To: Electoral Area Services Committee

Date: 2020-01-14

From: Graham Daneluz, Director of Planning & Development

Subject: Development Variance Permit 2019-17 for 155 First Ave, Cultus Lake Park, Area H

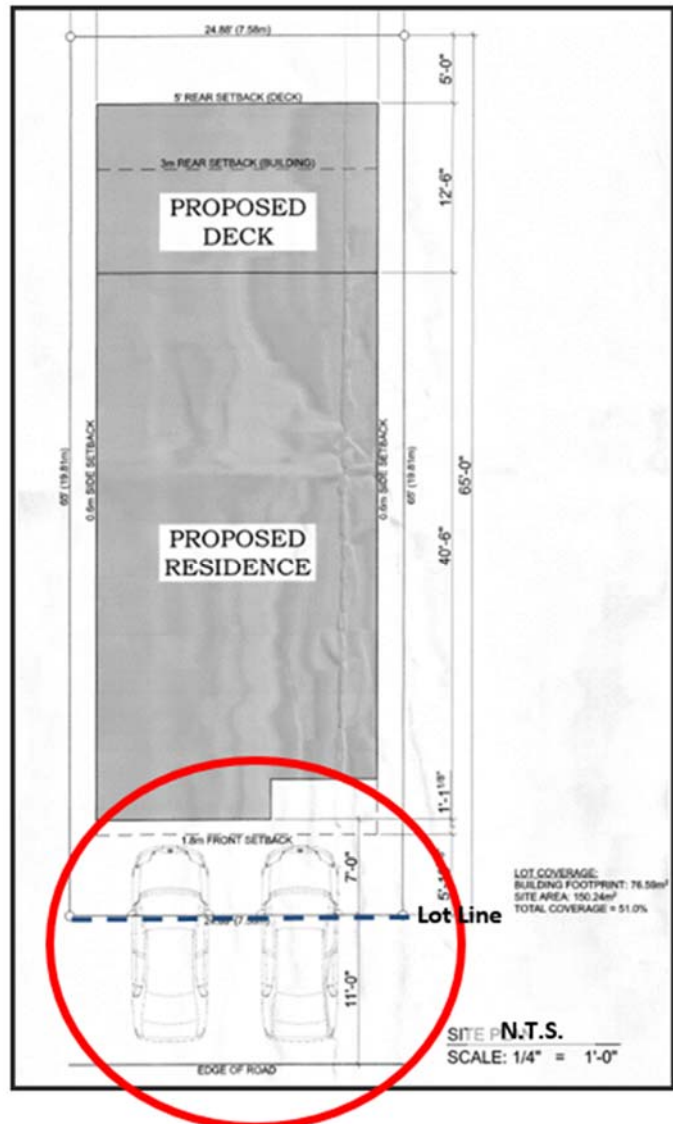
Cultus Lake Park Zoning Bylaw No. 1375 requires two off-street parking spaces on lots within the Waterfront Residential (R-3) zone.

The bylaw allows vehicles using parallel parking spaces to use a portion of the road width. However, the vehicle must be able to park entirely outside the travel lane delineated by the yellow lines painted on the road surface.

The applicant has requested a variance to reduce the number of off-street parking spaces from two to zero to allow the parking configuration shown at right. The proposed parking spaces would be oriented 90 degrees (perpendicular) to the road. They would extend 11 feet into the road allowance, but not into the travelled portion of the road, as shown below.

Nevertheless, there are a variety of issues associated with reliance on on-street parking. First Avenue is a one-way road with a travelled road portion of approximately 16 feet. Most areas outside of the vehicle travelling area are used for residential parking. The relatively narrow road width raises concerns about:

- Road safety for a variety of users; if road shoulders are entirely used for parking pedestrians, cyclists, and mobility scooters must travel in the portion of road intended for vehicles;
- Suitable travel width for road; cars appear to frequently park over the yellow line, in the travelled portion of the road, reducing road capacity;
- Service Vehicle Access (garbage, snow removal, contractors, emergency vehicles); often garbage/ recycling containers are placed on the travelled portion of the road; and,
- Space available for on-street parking will not meet the long-term demand for resident and guest parking.

Redevelopment provides an opportunity to reduce reliance on on-street parking. It is possible for the leaseholder to provide off-street parking spaces and meet the requirements of the zoning bylaw.

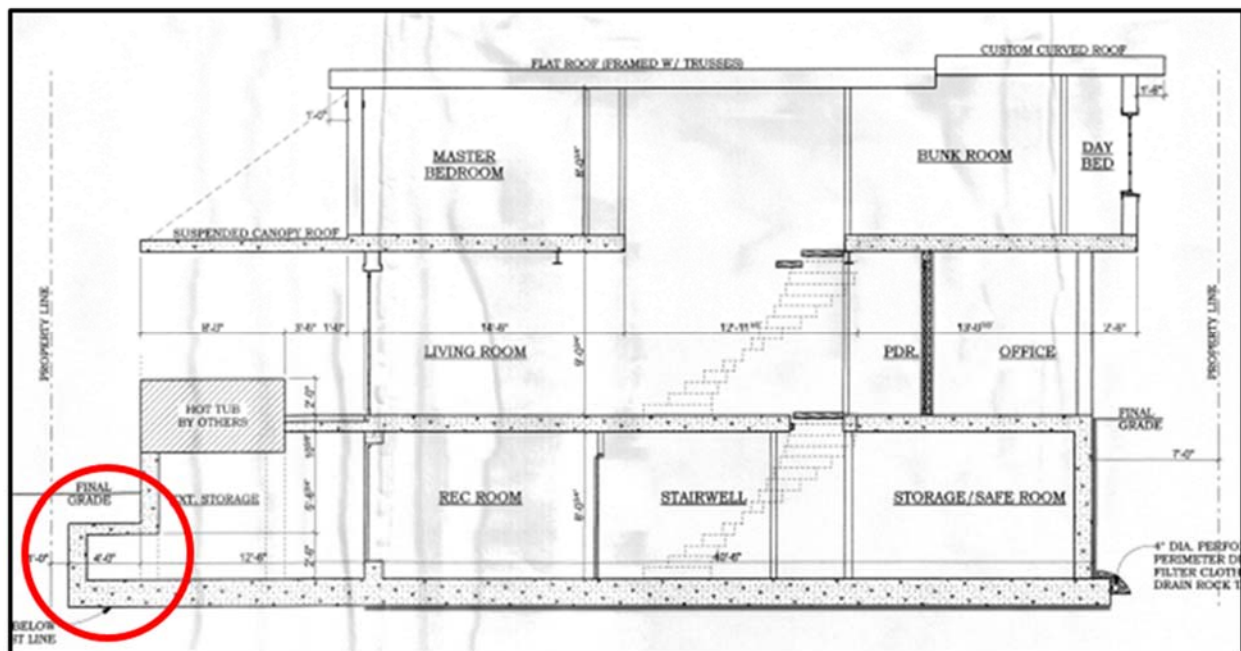
The FVRD Hazard Acceptability Thresholds for Development Approvals policy stipulates that new buildings subject to flood hazards with a probability of occurrence of 1:40 to 1:200 are approvable with protective works to mitigate the hazard.

The applicant proposes to provide mitigate in the form of a waterproof foundation. No designs or engineering certifications have been provided regarding the effectiveness of the proposed foundation. While some homes in the park have used this mitigation strategy, it is not a widely accepted practice. The Province of BC *Flood Hazard Area Land Use Management Guidelines* recommends that, "areas used for habitation, business, or storage of goods damageable by floodwaters should be constructed within any building at an elevation such that the underside of the floor system thereof is not lower than the designated flood level." This is consistent with the flood mitigation strategy set out in *FVRD Floodplain Management Bylaw No. 0681* and policies in Electoral Area official community plans.

Where local governments are considering a site-specific request to lower the minimum building elevations, or flood construction levels, the provincial guidelines state:

- The local government may alter a bylaw condition to best match the flood hazard provided the level of protection is not altered. This discretion extends to the reduction of elevation requirements, where flood plain mapping exists, by the freeboard (0.6 m).
- In order to avoid setting difficult precedents these site characteristics should be unique to the subject property and environs. The economic circumstances or design and siting preferences of the owner should not be considered as grounds for hardship.

This variance is inconsistent with provincial guidelines and FVRD policies. The submitted reports do not contain hydrological analysis and don't appear to meet the professional practice guidelines prepared by the Engineers and Geoscientists of BC for *Legislated Flood Assessments in a Changing Climate in BC* (the standard for flood hazard report in BC). Furthermore, the proposed mitigation measures are inconsistent with provincial guidelines and no design or engineering certification has been provided to assure their suitability and effectiveness.
